Interactive comment on “Inundation and groundwater dynamics for quantification of evaporative water loss in tropical wetlands” by J. Schwerdtfeger et al.

Received and published: 30 May 2014

Fig. 2.

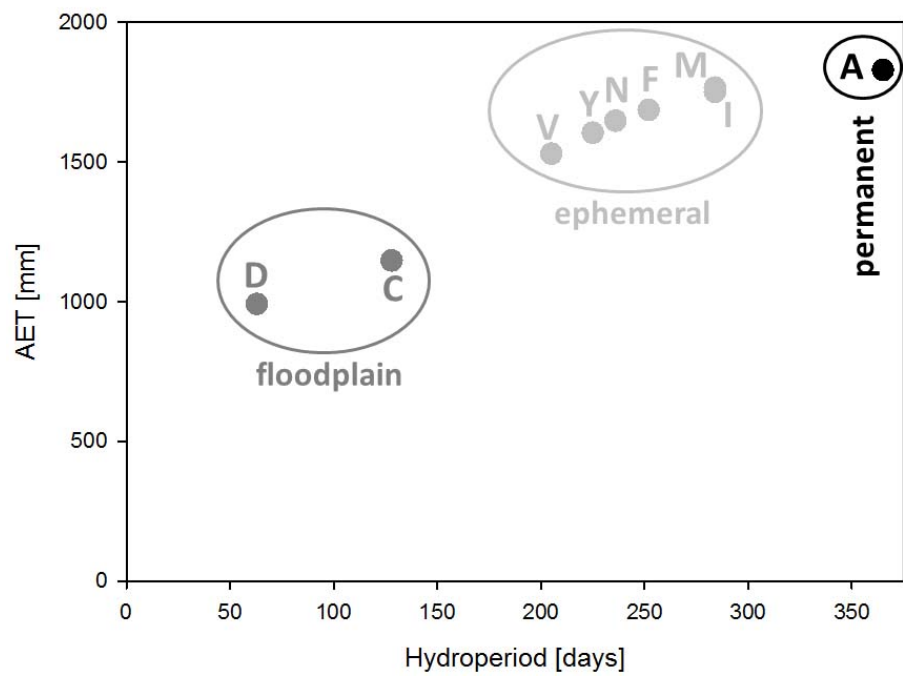
The data in Fig. 8 would be more compelling (to me anyways) by showing explicitly the strong covariance between total E and hydroperiod (annual duration of inundation). This relationship is definitely inferred from the graph, but a pairwise plot (total ET on the y-axis, hydroperiod on the x-axis) would be clearer. -> Thanks to the referee #2 for this valuable suggestion. This way the plot will be much clearer. We will change the graph as suggested (Fig. 2 of reply will replace Fig. 8 of manuscript). Accordingly, the term “hydroperiod” will also be used in the text. Figure caption: Relationship between total AET [mm] and hydroperiod (annual duration of inundation [days]) for studied water bodies (permanent, ephemeral, floodplain)
